TASK 203 – BASIC AND DETAILED DESIGN OF MEDUPI RAIL YARD AND OFFLOADING FACILITY

MEDUPI RAIL YARD AND OFFLOADING FACILITY CONCEPT REPORT – EXECUTIVE SUMMARY

Report reference number: 1184-099-4-100-R-0001-Rev03

Figure 11 – Layout of Rail Yard

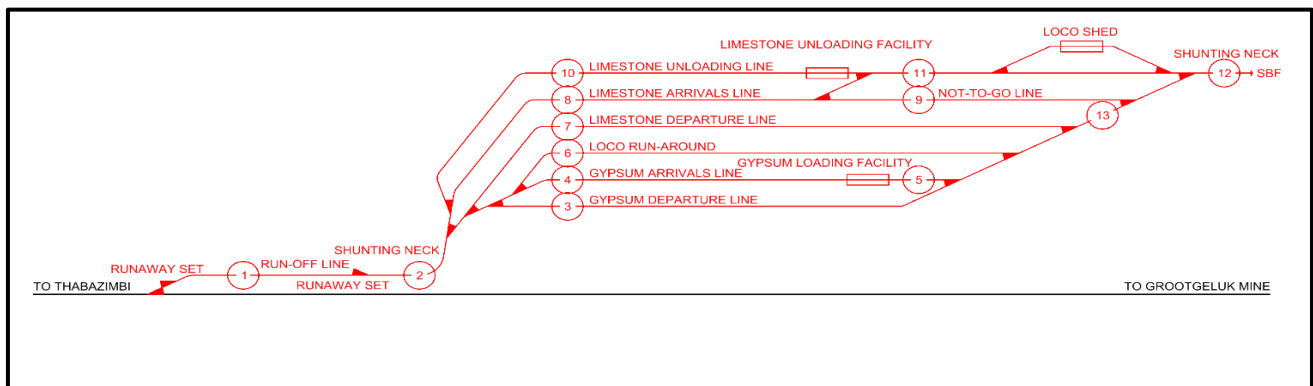
26	Concept layout drawing 0.84/40134	Fence clashing with the stormwater trench. There is no space for an access road next to the fence. The fence will need to be rerouted or perhaps a retaining wall will be required ?	Civils – Tony Haupt	<p>The fence position is dependent on the railway line position. Space should be provided for the service road of the fence. The retaining wall option will be investigated during the detail design stage.</p> <p>This will be dealt with in the next phase of the project. <u>Action: W. Kusel</u></p>
27	Concept layout drawing 0.84/40134	The terrace is over the stormwater trench. A large culvert an perhaps a redesign of the drainage system will be required.	Civils – Tony Haupt	<p>The existing stormwater trench will be replaced by culverts to join the existing culverts. The existing stormwater culvert sizes will be reviewed in conjunction with the new proposed culverts.</p> <p>This will be dealt with in the next phase of the project. <u>Action: W. Kusel</u></p>

28	Concept layout drawing 0.84/40134	The fire water valve pit is under the embankment. It will be necessary to relocate it to the South.	Civils – Tony Haupt	Will relocated the valve pit to an appropriate position. This will be dealt with in the next phase of the project. <u>Action: W. Kusel</u>
29	Concept layout drawing 0.84/40134	The Limestone and Gypsum Substation is not indicated and there is a clash with the fence.	Electrical, Civils – Tony Haupt	Will include Eskom’s planned Limestone substation in concept layout drawing. Will move the fence to a suitable position after final placement of Limestone and Gypsum Substation on the approved layout plan. This will be dealt with in the next phase of the project. <u>Action: W. Kusel/ S. Inderlall</u>
30	Concept layout drawing 0.84/40134	The fence is clashing with the access road for Gypsum Stockpile.	Civils – Tony Haupt	Will move fence to suit Gypsum stockpile access road This will be dealt with in the next phase of the project. <u>Action: W. Kusel</u>

31	Concept layout drawing 0.84/40134	This manhole is covered by the terrace.	Civils – Tony Haupt	The manhole should be relocated to the south of the terrace footprint. This will be dealt with in the next phase of the project. <u>Action: W. Kusel</u>
32	Substation and cable route 0.84/40138	This substation is shown in the incorrect position see drawing 0.84/3 Station Layout and 0.84/40134 Main Concept Layout.	Electrical – Tony Haupt	From drawing 0.84-567-01-08 (received from Mr Van Wyk) the planned limestone storage sub is indicated correctly on drawing 0.84/40134-Substation and cable route. This will be dealt with in the next phase of the project. <u>Action: S. Inderlall</u>
33	Substation and cable route 0.84/40138	This lighting mini sub is directly next to the Gypsum and Limestone Substation see drawing 0.84/3 Station Layout and 0.84/40134 Main Concept Layout.	Electrical – Tony Haupt	The lighting mini sub is a proposed mini sub where the position can be changed, there is a possibility of using existing ring feed mini subs at Medupi for lighting as discussed with Mr Van Wyk and there might not be a need for this mini sub.
